URBAN DESIGN REVIEW PANEL REPORT

Project:	2213 – 1657 Carling Avenue	Date:	01 October 2024
Hearing Date:	07 September 2023	Pages:	48
Comments Received:	10 October 2023		
File No.	PC2024-0317 / D02-02-24-0032

RESPONSE TO UDRP RECOMMENDATIONS

Figure 1: The maximum floor plate size of 750 sq m includes all built areas, such as dwelling units, offices, indoor amenity facilities, elevator cores, storage spaces, stairwells, hallways, etc., but **excludes inset or projecting balconies.**

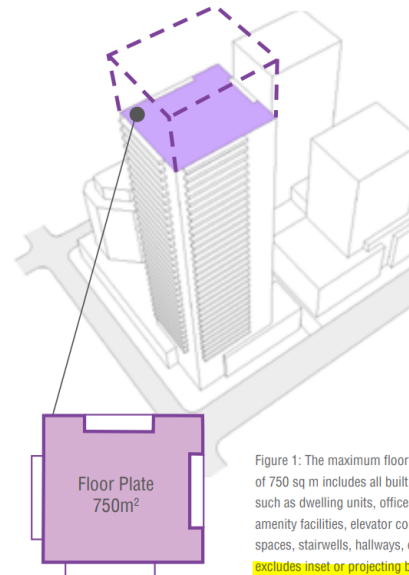
- *The Panel highly recommends the City's high-rise guideline of 750m² floorplates, inclusive of balconies, should be adhered to. As it stands, there is not a strong enough rationale for this project to be granted special consideration to this guideline.*
We understand that tall building guidelines are not standards but recommendations to be considered. We would question why a building that provides balconies would have a limitations on indoor space that a building without balconies would not face. Does this not encourage un-articulated buildings that are devoid of balconies? Is this the direction that is intended for high-rise buildings? I would also question why the 750m² floor plate includes balconies where the Toronto guidelines upon which Ottawa's were based does not.

3.2.1 FLOOR PLATE SIZE AND SHAPE

Limit the tower floor plate to 750 square m or less per floor, including all built area within the building, but excluding balconies.

1657 CARLING AVENUE FLOOR PLAN - GROUND FLOOR

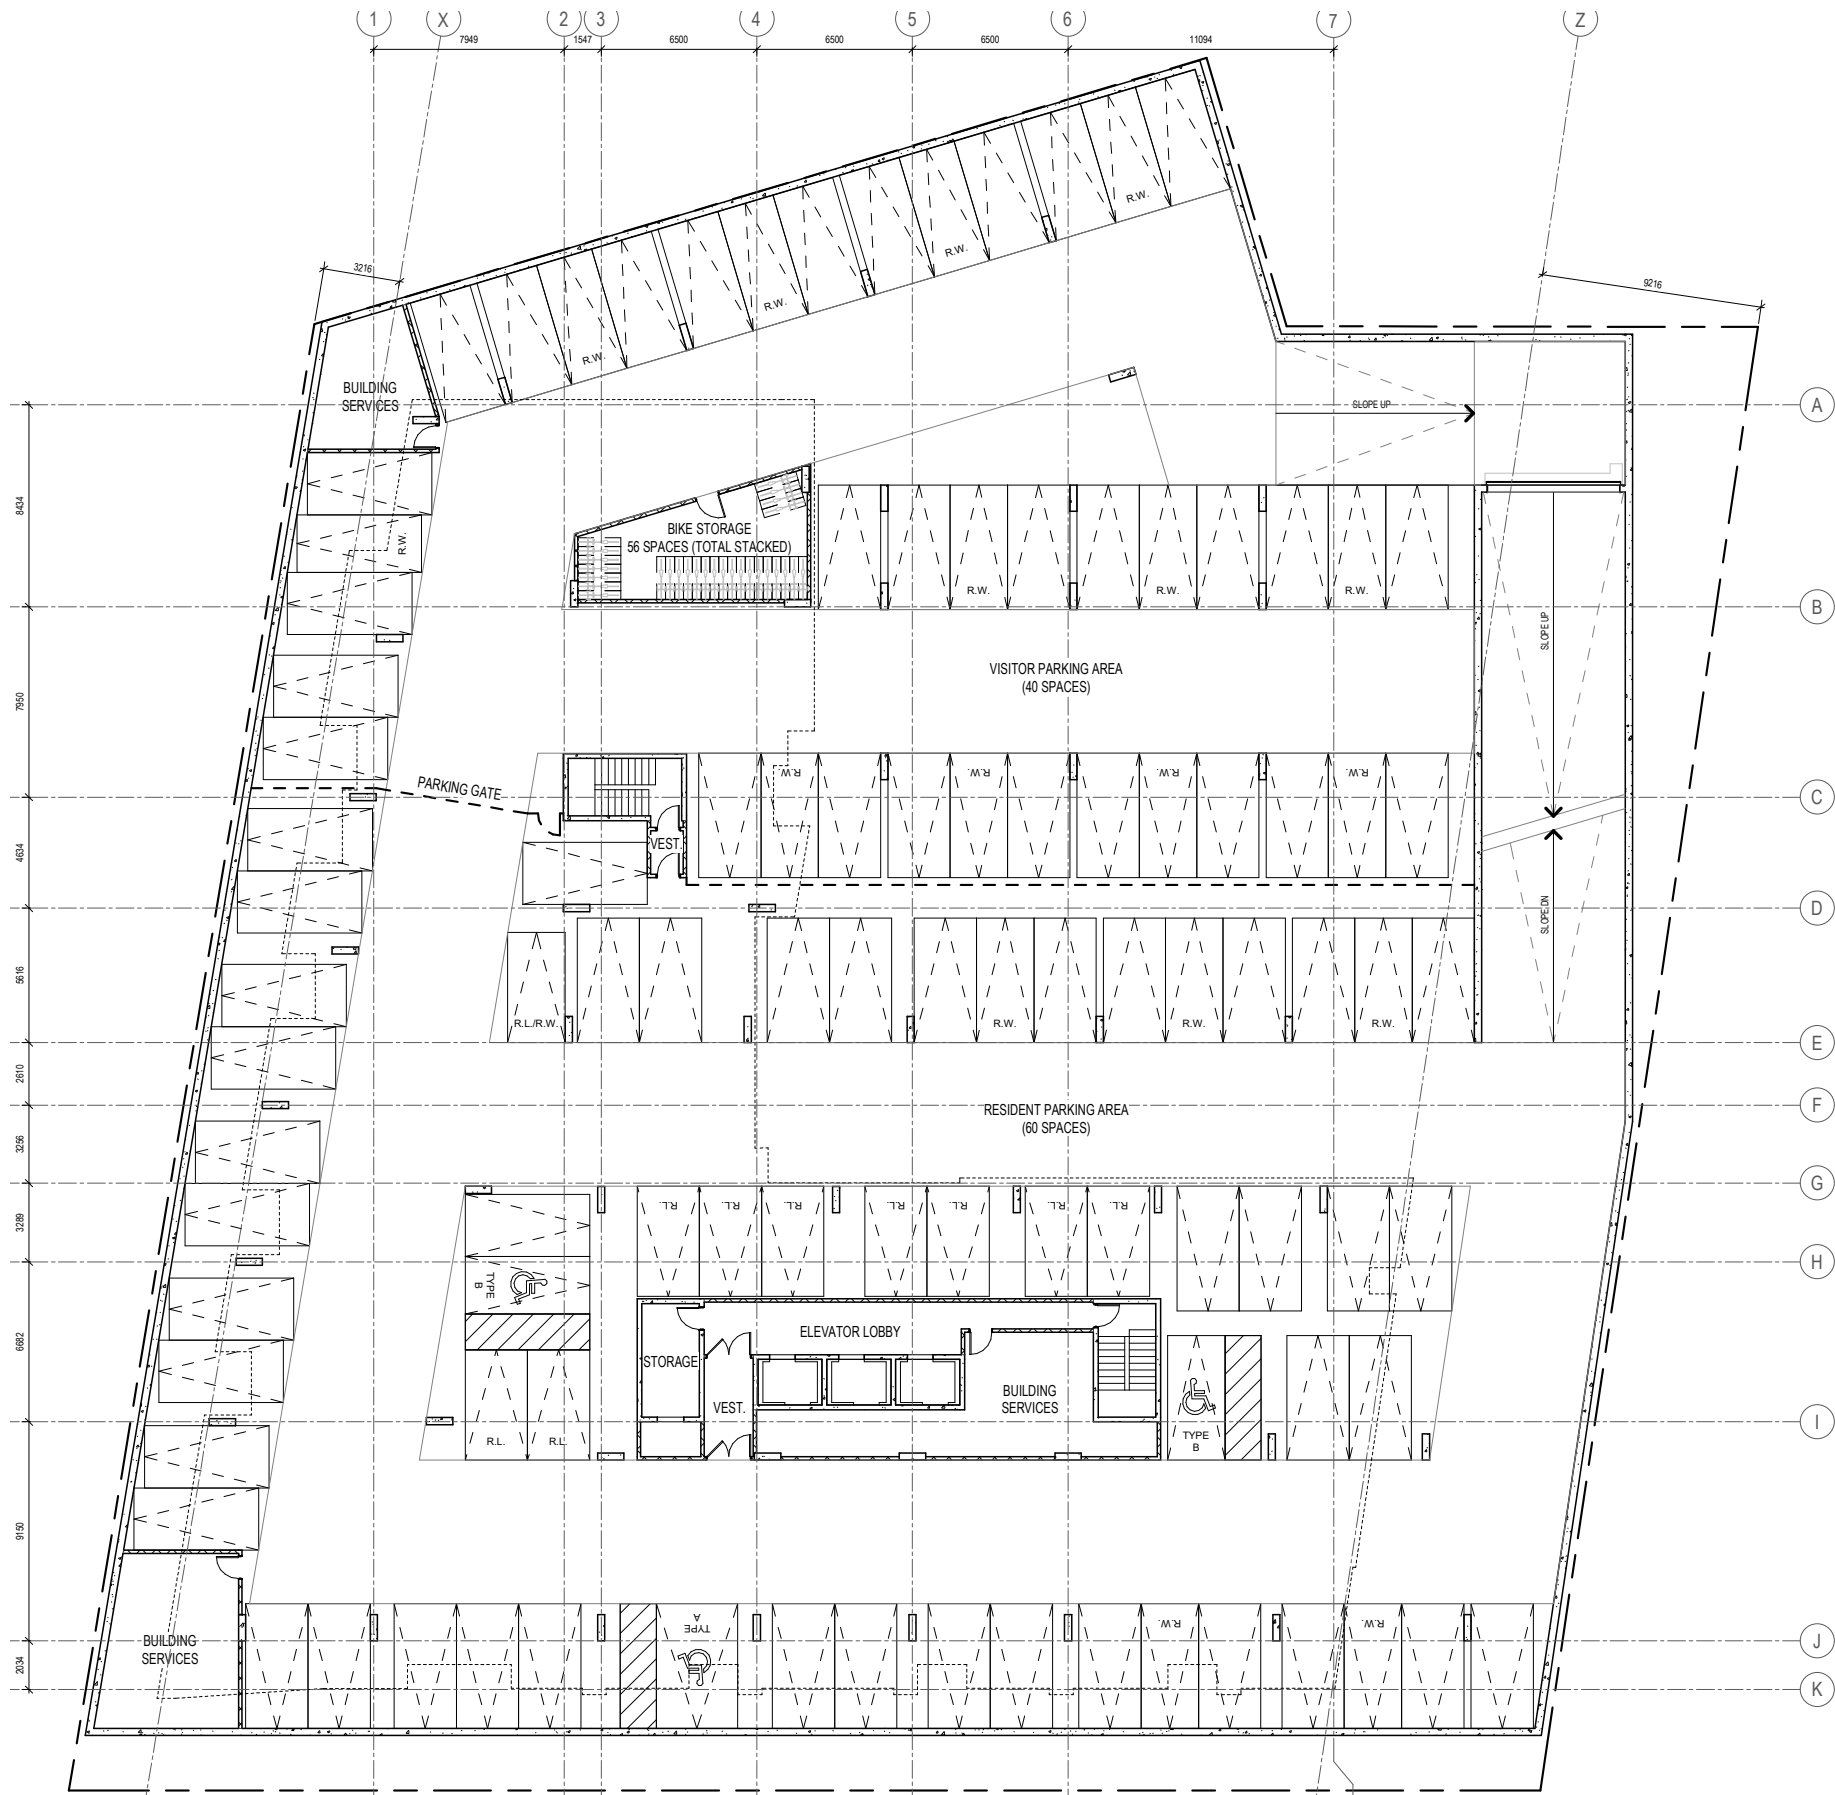
- The Panel highly recommends pursuing a generous through lobby from the south-west corner of the building (where amenity workspaces are) to enhance and improve the building's access and presence along Carling Avenue.

- Consider merging the amenity workspaces with a grander lobby area to enhance that through lobby experience as much as possible.
Noted.
- The Panel recommends ensuring that the podium heights and street-wall align with the adjacent existing and proposed buildings.
Noted, the podium and street-wall are in alignment with the development at 1655 Carling, immediately to the east of the subject site.

- The Panel recommends providing more depth to the commercial spaces to help them be successful.
Noted.
- The Panel recommends removing the amenity space on the ground floor or merging it with a through-lobby entrance at the corner of the building.

- Consider moving the bike storage space to the west side of the building, closer to Carling Avenue and creating a through-lobby area.
Noted.
 - Consider placing any ground floor amenity space on the courtyard/forecourt, potentially swapping with the bike storage area.
We strongly disagree with the suggestion to position a bicycle storage room along the street frontage instead of an amenity space that is designed to promote interaction with the street. Note that the primary outdoor amenity space for the building will be the terrace on the 10th floor facing north, which also features an indoor amenity room. The courtyard space at the entrance to the building is meant more to create a sense of arrival and to facilitate departure.
